MECKLENBURG COUNTY HEALTH DEPARTMENT

APPLICATION FOR PERCOLATION TEST

SUBJECT: Apt. 7251 (T. B. Harkey)
Lot No. 11, Block 1, Stoney Ridge Drive
Pine Island Country Club
4-19-74

SITE DISAPPROVAL REPORT
INDIVIDUAL SEPTIC TANK SYSTEM WITH SUBSURFACE, SOIL ABSORPTION, EFFLUENT DISCHARGE

7) ACCURATELY DIAGRAM & DIMENSION LOT

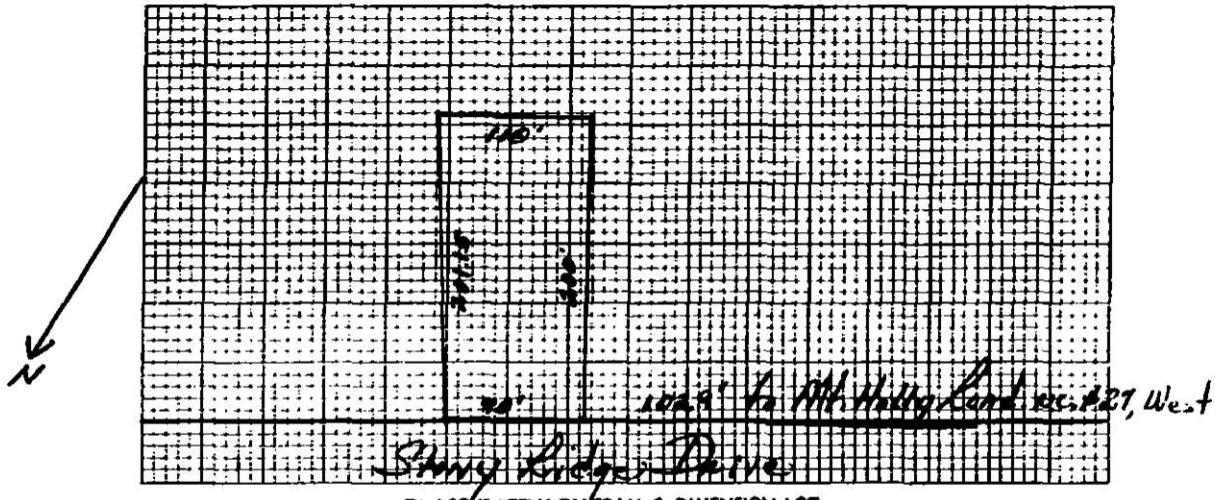
The lot consists of soils of the Enon series. These soils have plastic and sticky clay subsoils which contain swelling clay minerals. These soil characteristics result in inadequately slow permeability and percolation rate.

Based on this investigation, the lot appears unsuitable for installation of a septic tank system.

X ON SITE INSPECTION REVEALED LOT TO BE UNSUITABLE FOR THE FOLLOWING REASON(S) 4-19-74 - The lot consists of soils of the Iron series. These soils have plastic and sticky clay subsoils which contain swelling clay minerals. These soils characteristics result in inadequately slow permeability and percolation rate.
